ENSTROM HELICOPTER CORPORATION

SERVICE DIRECTIVE BULLETIN NO. 0095

Revision 1

1. SUBJECT: Idler Pulley Actuator Arm Inspection
2. MODEL: F-28A, F-28C, F-28F, 280, 280C, 280F, and 280FX
3. EFFECTIVITY: All Serial Numbers
4. BACKGROUND:

Figure 1. Actuator Arm Configuration

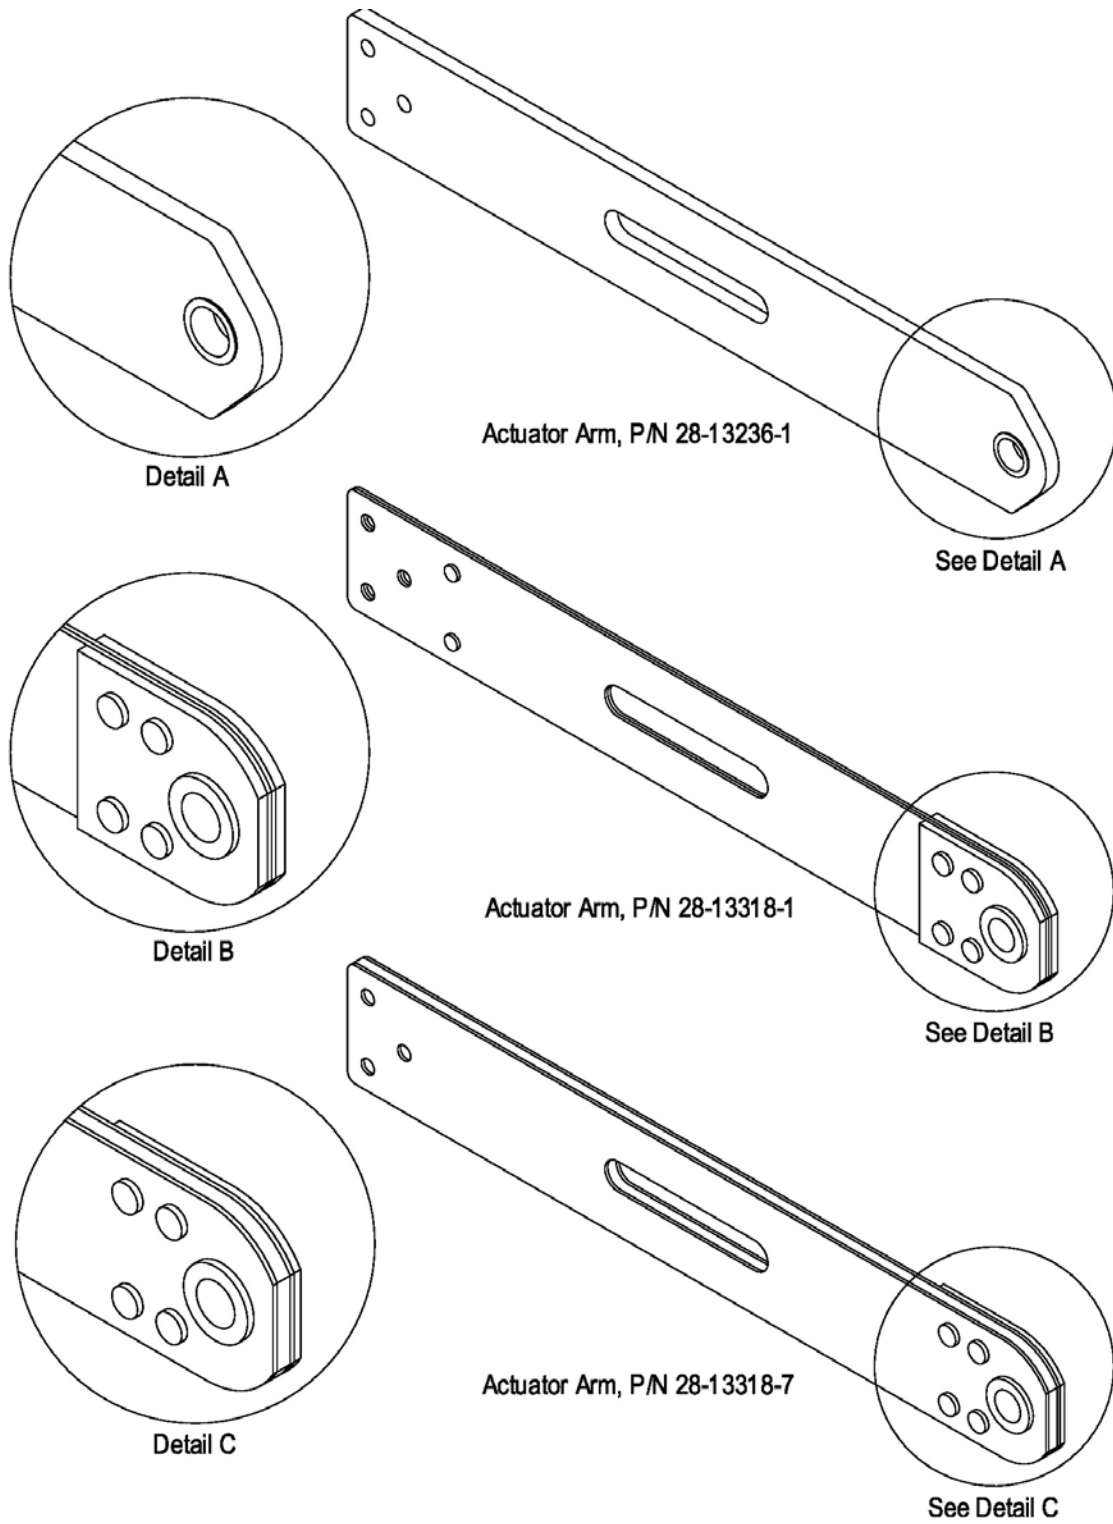
There are three configurations/part numbers for the actuator arm (See Figure 1): 28-13236-1, consisting of a single aluminum plate, was used on all aircraft manufactured prior to January, 1981 (The original issue of this SDB required replacement of 28-13236-1 with 28-13318-7, which is still in effect.); 28-13318-1, consisting of two steel plates, was used on all aircraft manufactured between January, 1981, and January, 1992; and 28-13318-7, consisting of 2 steel plates and 1 aluminum plate, is currently in use since February, 1992.

Revision 1 of this Service Directive Bulletin mandates replacement of actuator arm part number 28-13236-1, if still in service, as well as replacement of part number 28-13318-1 with airworthy part number 28-13318-7, and one time and repetitive 100 hour inspections of the actuator arm assemblies.

- A. At or before the next 50 hour inspection, replace any 28-13236-1 or 28-13318-1 actuator arm assemblies with airworthy 28-13318-7 actuator arm assemblies. Perform all maintenance in accordance with the applicable aircraft model maintenance manual and Service Information Letter 0152, Belt Tension Adjustment and Idler Pulley Alignment.

Figure 2. Actuator Arm Inspection

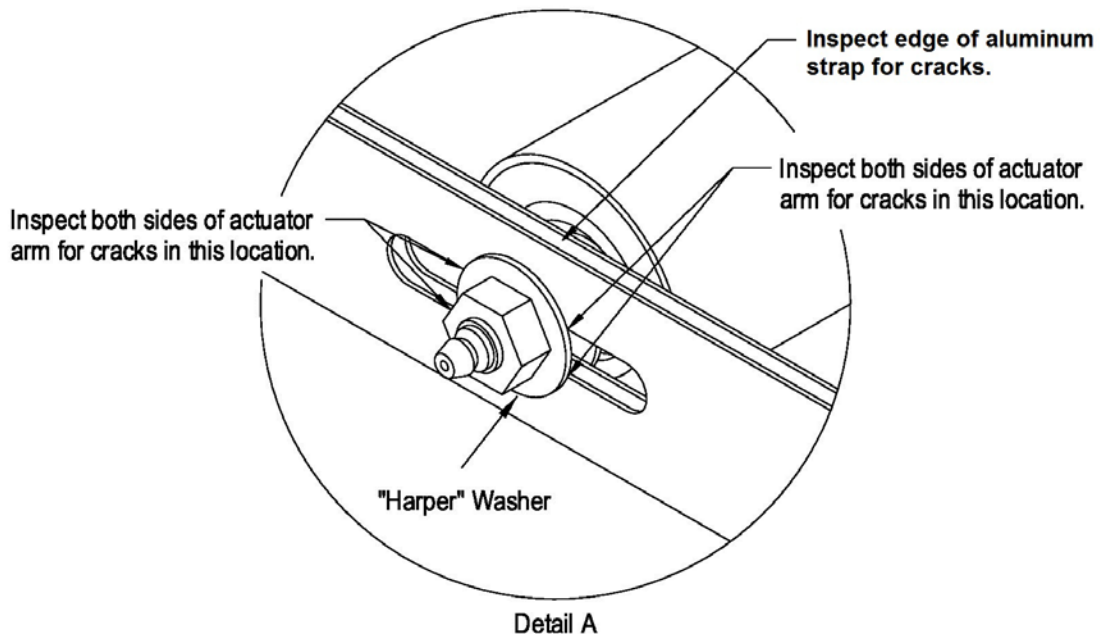
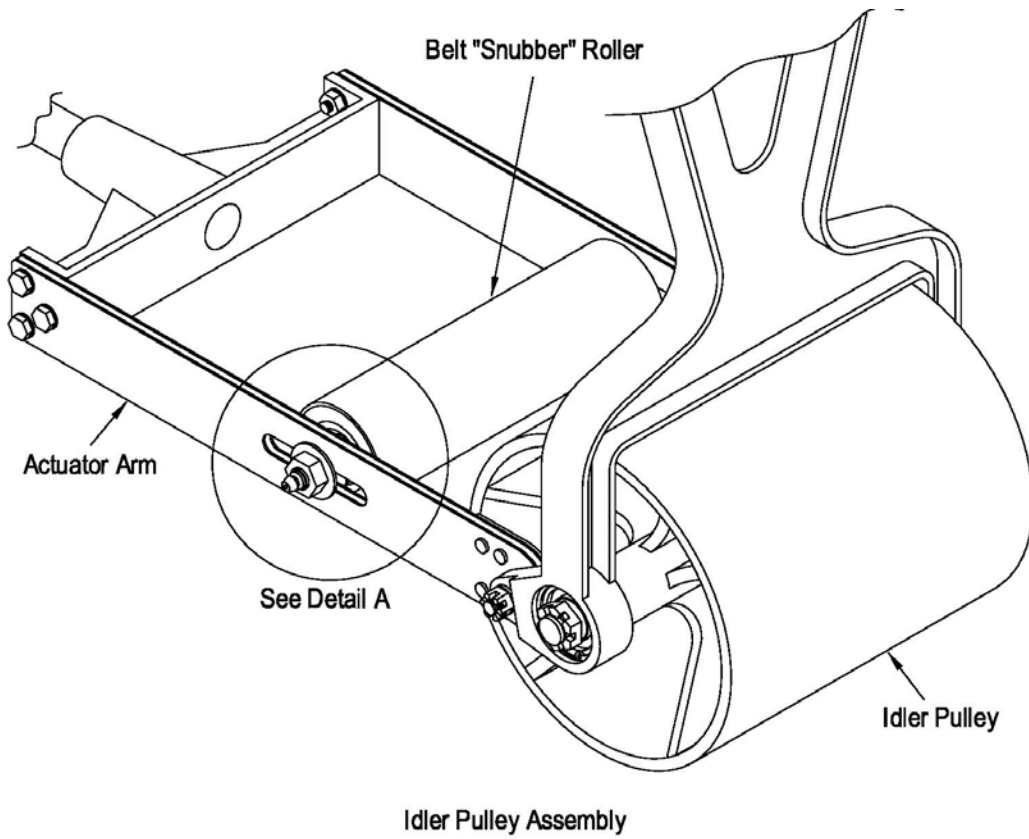
- A. Remove the aircraft cowling as required to access the belt tensioning and idler pulley system.
- B. Note the location of the belt "snubber" roller "Harper" washers on the actuator arms (See Figure 2).
- C. Loosen the nuts securing the roller and reposition the roller to allow access to the area where the "Harper" washers were located.
- D. Clean the actuator arm.
- E. Using a suitable flash light and inspection mirror, inspect the edges of the "Harper" washer area (inside the groove) on the actuator arm for cracks and inspect the outside edges of the actuator arm above and below the "Harper" washer area for cracks.

The interior aluminum plate will normally fail first.

- F. If no cracks are found, move the roller back into position and set the final positioning in accordance with Service Information Letter 0152, Belt Tension Adjustment and Idler Pulley Alignment.

- G. If cracks are found, remove the actuator arms and install airworthy actuator arms, P/N 28-13318-7. Set the position of the belt “snubber” roller in accordance with Service Information Letter 0152, Belt Tension Adjustment and Idler Pulley Alignment.
